CLIMATE
ACTION
RESERVE

SUMMARY OF COMMENTS & RESPONSES DRAFT MEXICO FOREST PROTOCOL VERSION 2.0

Figure 1. Distribution of diameter measurements of 15-year old mangrove trees of San Crisanto. Mangroves with 2.5 cm DBH are considered adult.

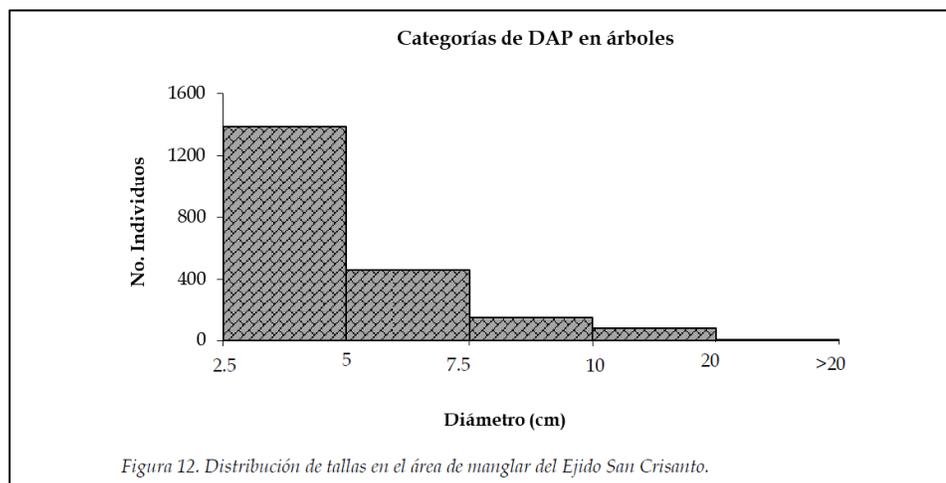
37. COMMENT: In mangroves, the age of the forest is not determined by the radial increment of the tree trunks, for example, if the nutrient availability is low, the mangrove forests invest less energy in growing the biomass of tree trunks and increases the root biomass and cover volume. Thus, trees with 2.5-5 cm DBH and more than 5 years old should be incorporated in the measurement of the tree biomass using the canopy volume and DBH (which is generally between 2.5 and 5 cm). We would recommend that the Reserve consider including mangroves of bush and chaparral type, since this kind of mangrove is dominant in the Yucatan Peninsula and the Pacific North of the country. The Ejido Siscal, in the Yucatan, has close to 1000 hectares of mangrove forest and wishes to aggregate with the Ejido Ursulo Galvan and San Crisanto projects, but close to 79% of the mangrove cover is bush cover. We think that one could measure the forest growth and issue credits under the MFP if the mangrove chaparral areas were included in Activity Areas where the canopy volume is measured, in addition to the other variables. The growth rates can be determined through the annual diameter increment or annual canopy volume increment. **(Fundación San Crisanto)**

RESPONSE: Thank you for your comment. The Reserve will modify the language to state that the 5cm DBH minimum is a recommendation, but that projects may include trees with smaller diameters if the Forest Owner determines that the benefits of including smaller trees will outweigh the added costs. Forest Owners will need to clarify the adjusted minimum DBH in the Project Report, and verifiers will likewise need to include trees of all sampled sizes in the verification.

The Reserve will additionally consider applying the canopy cover methodology to mangrove forests for a future update.
